Master File #: PD-2020-002;

SUBJECT: Response to Incompleteness Letter (PD-2020-002 – 2889 SE Hillside Ct)

HILLSIDE MASTER PLAN

APPLICATION FOR A PRELIMINARY PLANNED DEVELOPMENT

VEHICULAR CIRCULATION & ON-SITE PARKING

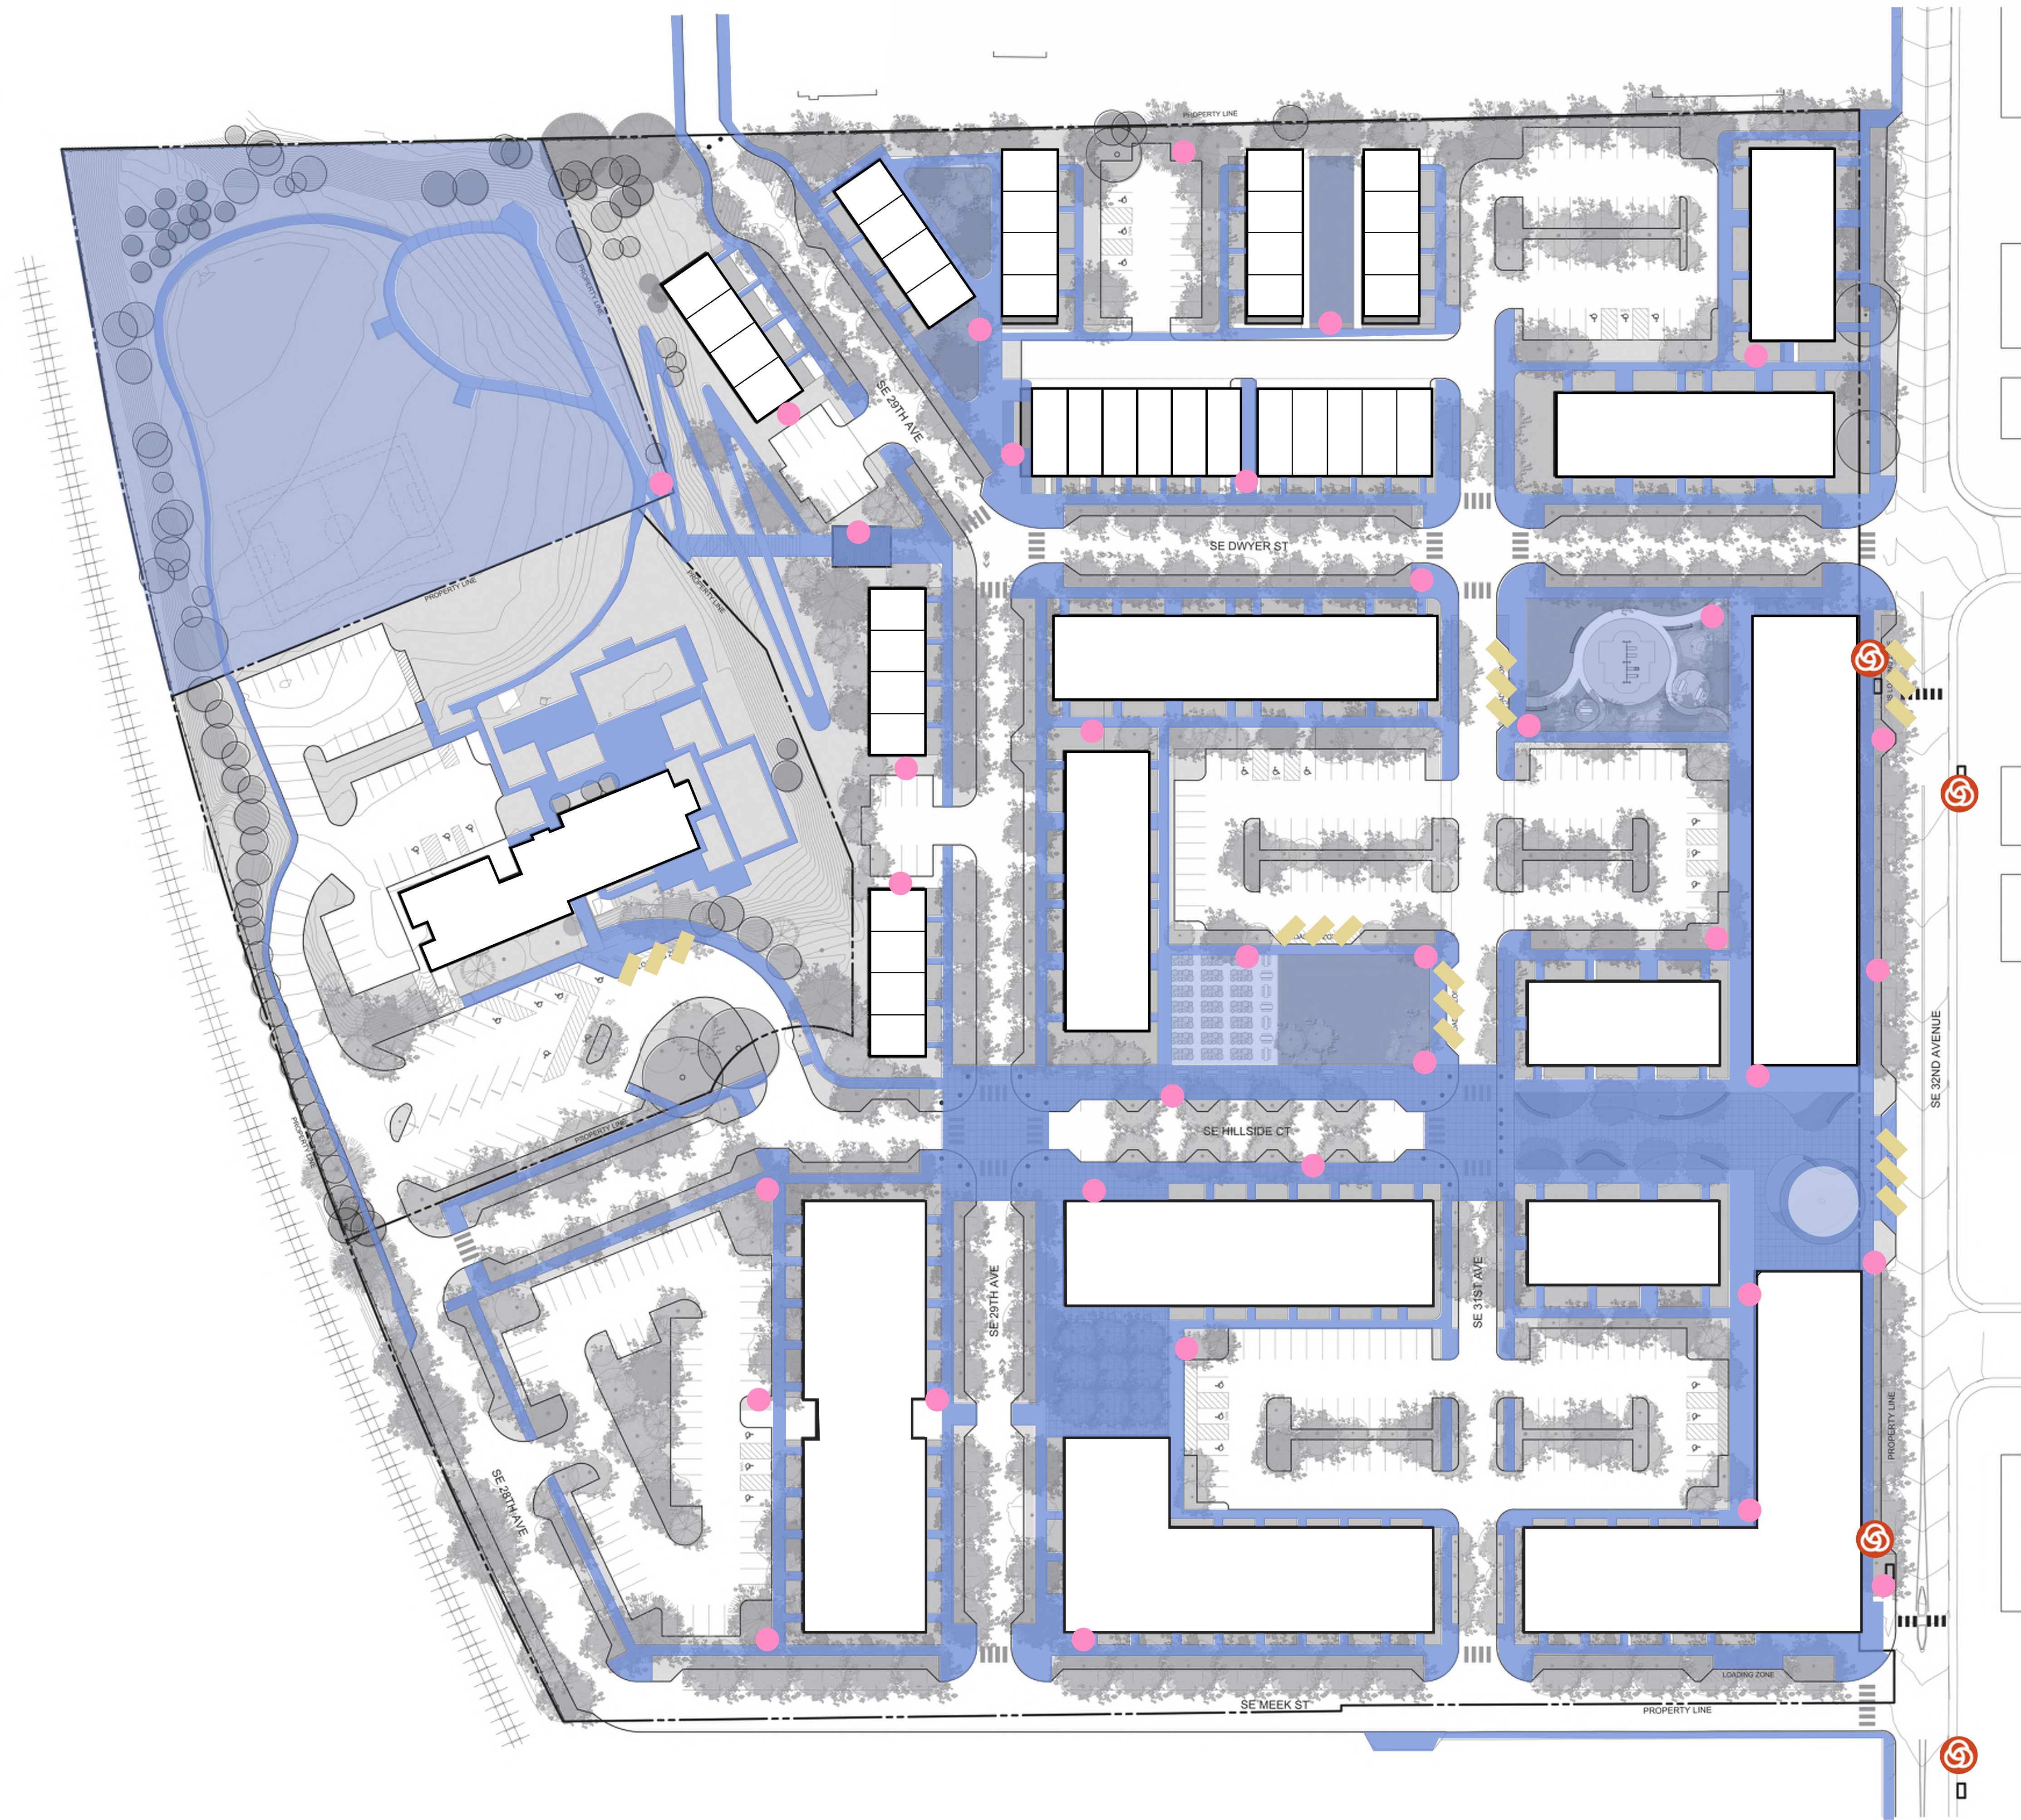
Response: A revised TIS has been submitted with this letter addressing the issues raised in the incompleteness letter. Additionally, after meeting with Steve Adams on December 16th, it was agreed that a new left-turn lane providing queuing for vehicles traveling north on SE 32nd Avenue and turning left onto SE Meek Street will need to be constructed as part of the development. Sketches showing where this turn lane will be located and how it will be configured have been provided with this letter. Additionally, a note has been added on sheet MP 1.6 (Vehicular Circulation Plan) that indicated that this turn lane will be provided, however, because the entire improvement will be located off-site it has not been shown on the master plan itself.

1. Revised Transportation Impact Study (electronic)
2. Revised Narrative (electronic)
3. Left-hand turn lane studies (electronic)
4. Revised sheet 1.6 (electronic)
5. Copy of email from TriMet

Proposed Northbound
Left-Turn Lane

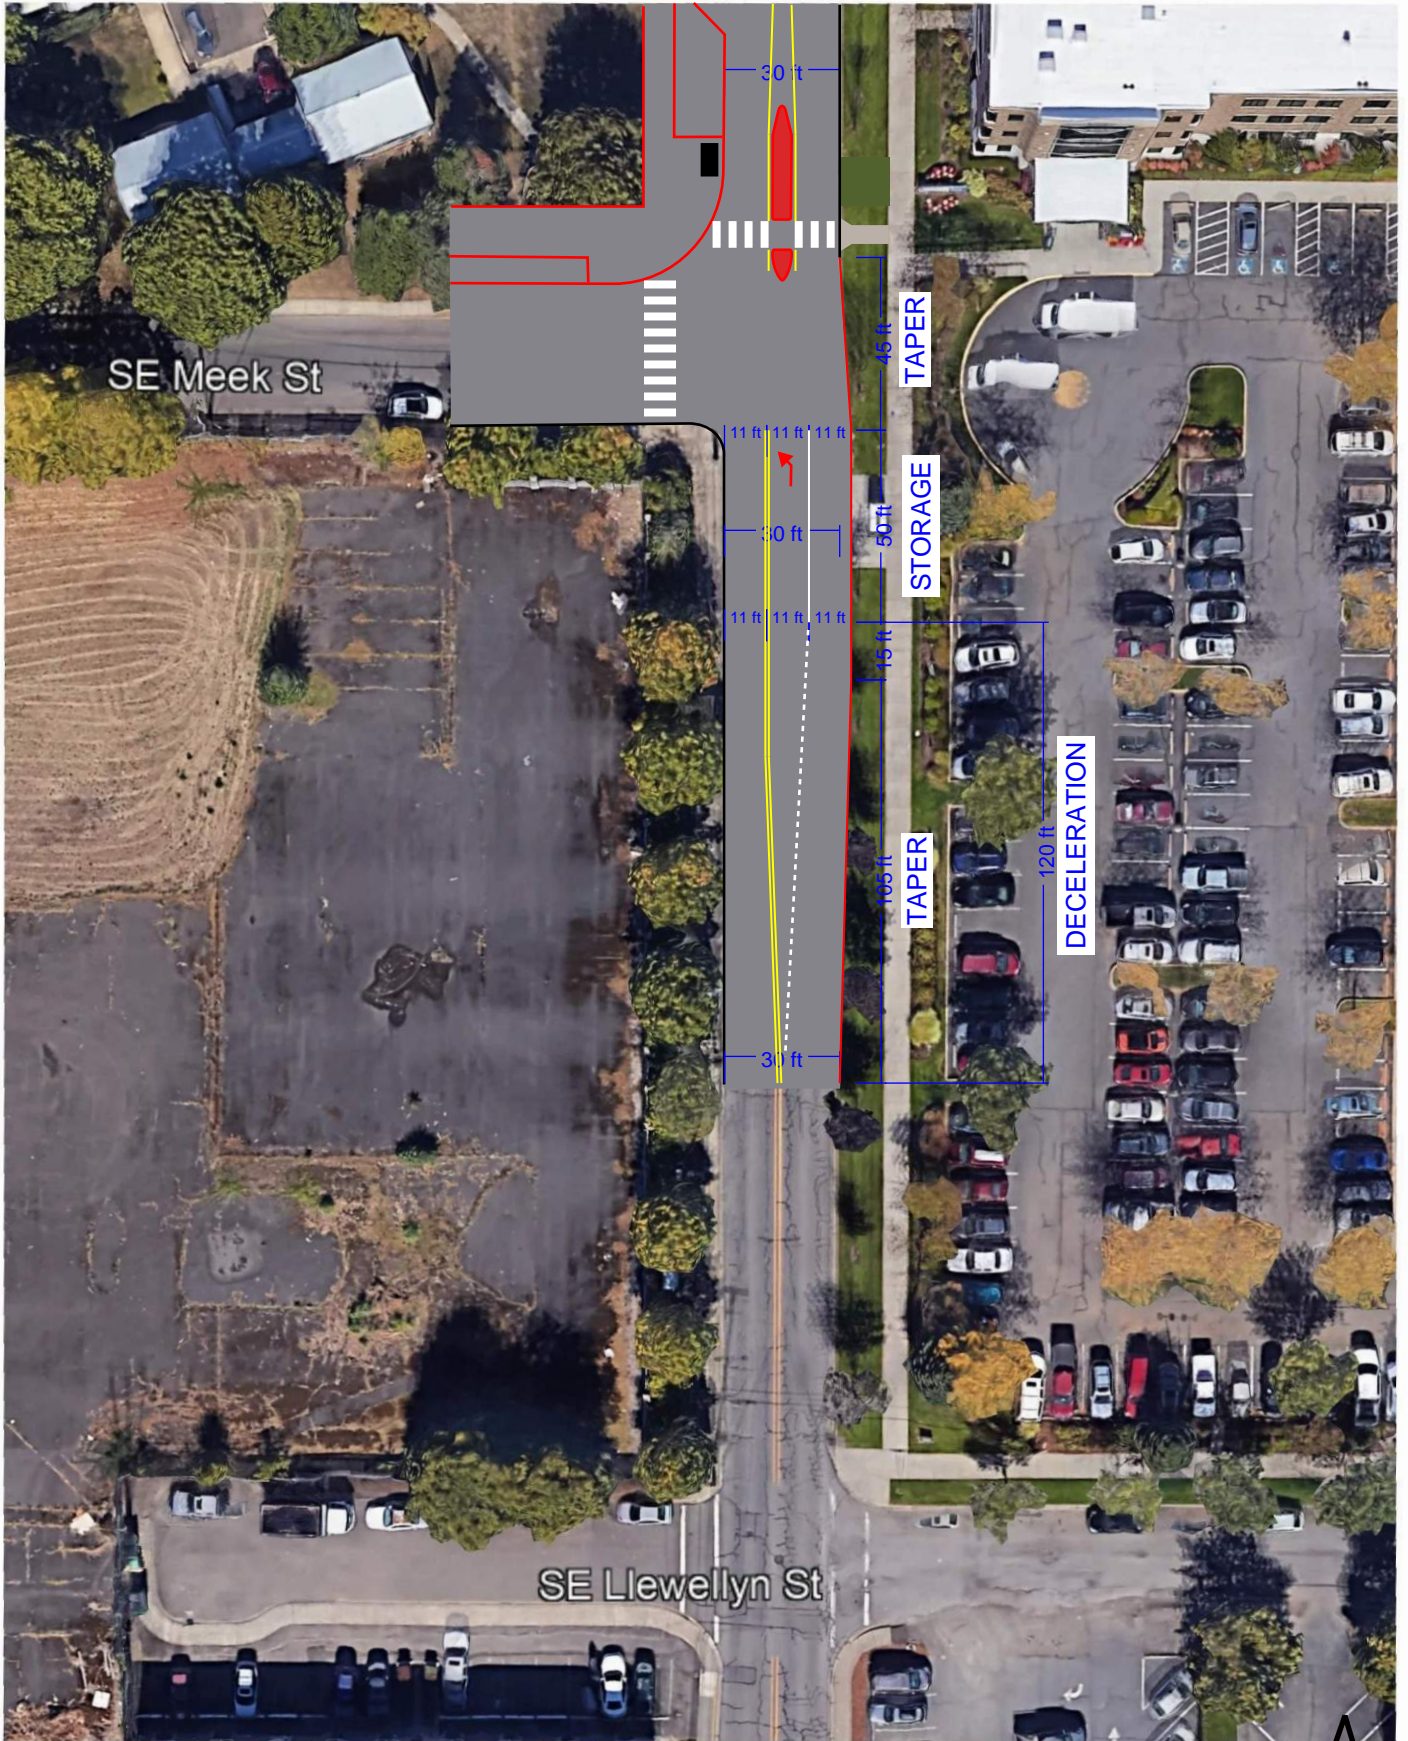
Response: The amended TIS study now proposes construction of a left-turn lane from northbound SE 32nd Avenue onto SE Meek Street. The warrant is not met with Phase 1 of the project, which includes 209 dwelling units but is expected to be met when 325 to 350 units are constructed on the site. A storage length of approximately 50 feet should be provided and the pedestrian crossing on the north side of the street should be moved southward to align with new ramps on the northwest corner of the intersection.
